Golden Gate Bridge Physical Suicide Deterrent System Project

Final Environmental Impact Report and Environmental Assessment and Section 4(f) Evaluation with Finding of No Significant Impact

January 2010

FIGURE 2.1-2
EXISTING AND FUTURE LAND USES: MARIN APPROACH

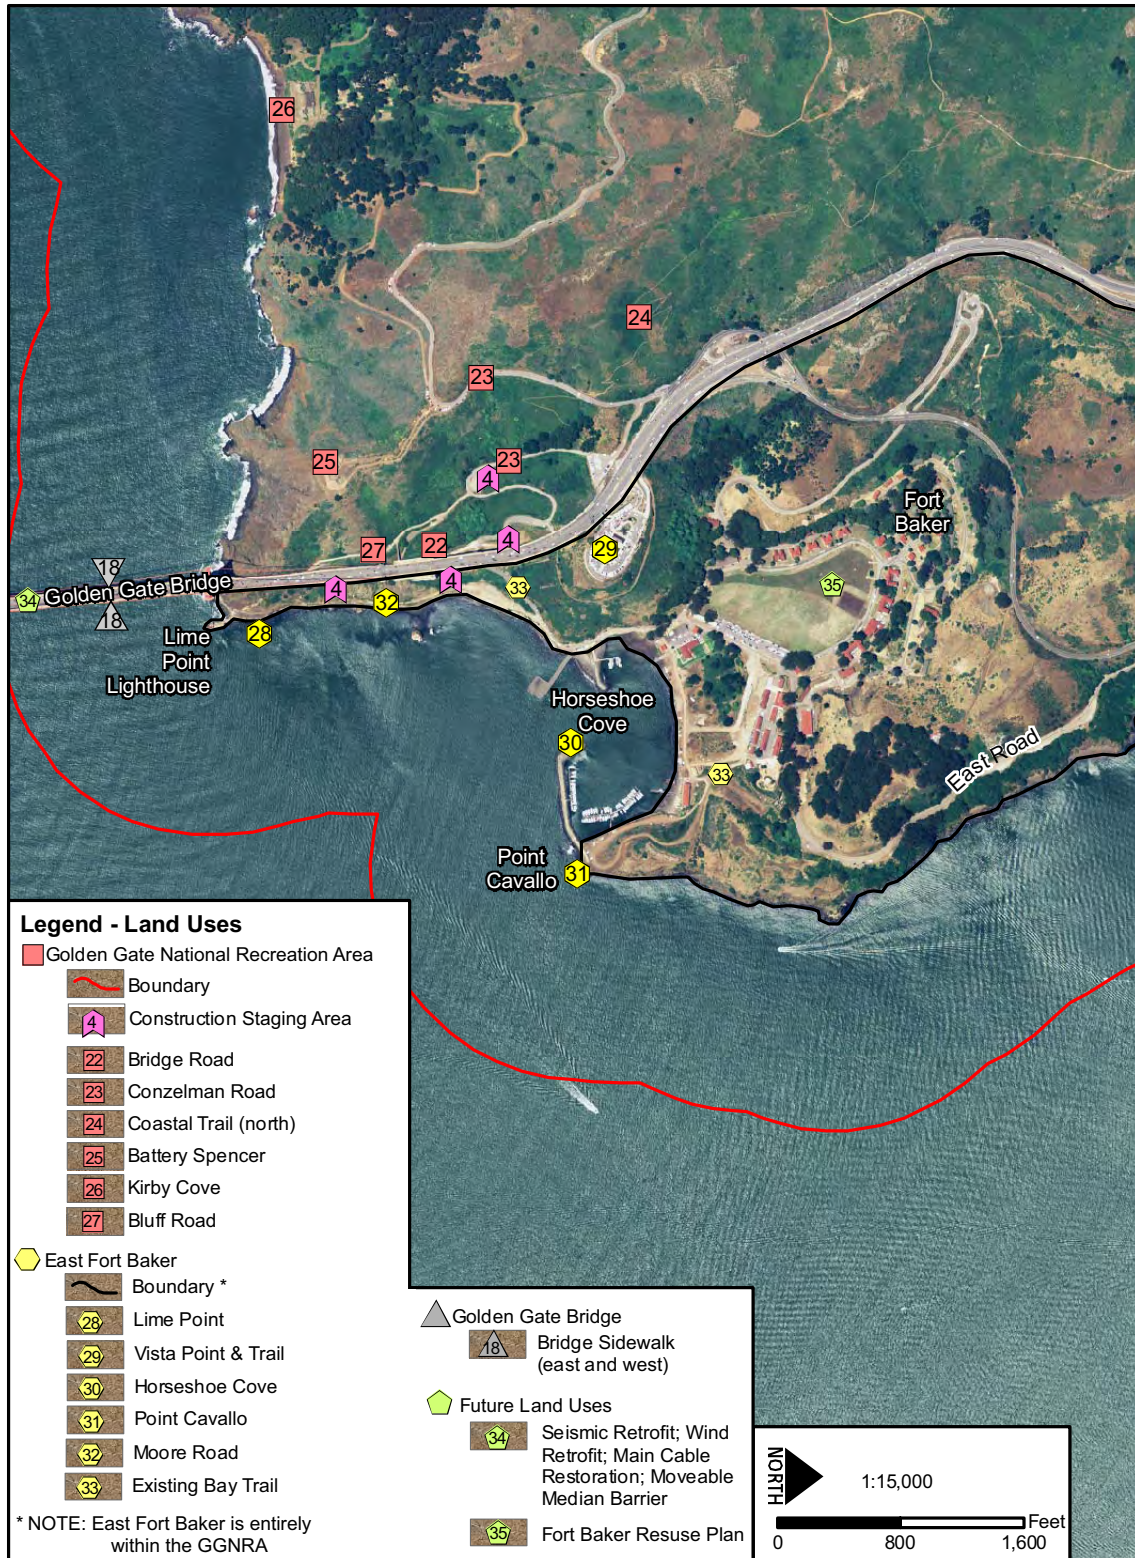
Commenter requests a correction be made to Figure 2.1-2 to show the legislative boundary of the GGNRA and to show all of East Fort Baker as part of the GGNRA. The commenter also requested that construction staging areas shown on this figure have a distinct color and symbol.

Figure 2.1-2 has been updated accordingly; see page 2-4 and Appendix B, page 12, of the Final EIR/EA.
